MOTORCYCLE PARTS NEWS

NUMBER 387

TX750 — VALVES AND VALVE SPRING LOCK, Change in Design

TX750 VALVES AND VALVE SPRING LOCK, Change in Design (cont.)

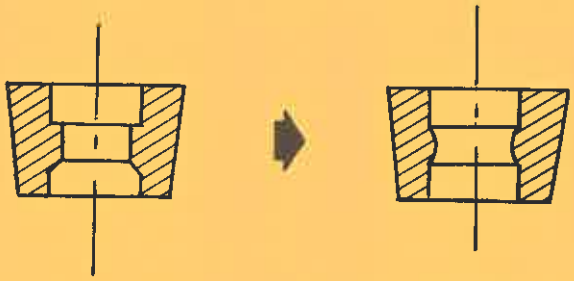
Intake and Exhaust valve stems and valve spring retainer locks have been redesigned to improve locking strength. Please make the following additions to your TX750 Parts List (2nd Edition).

VALVE STEMS

OLD TYPE NEW TYPE

VALVE SPRING LOCKS

OLD TYPE NEW TYPE

1. Old type Intake and Exhaust valves will no longer be available. When ordering new type, be sure to order new type valve spring locks (P/N 341-12118-00-00).
2. Both old and new types of valve spring retainer locks are available now.
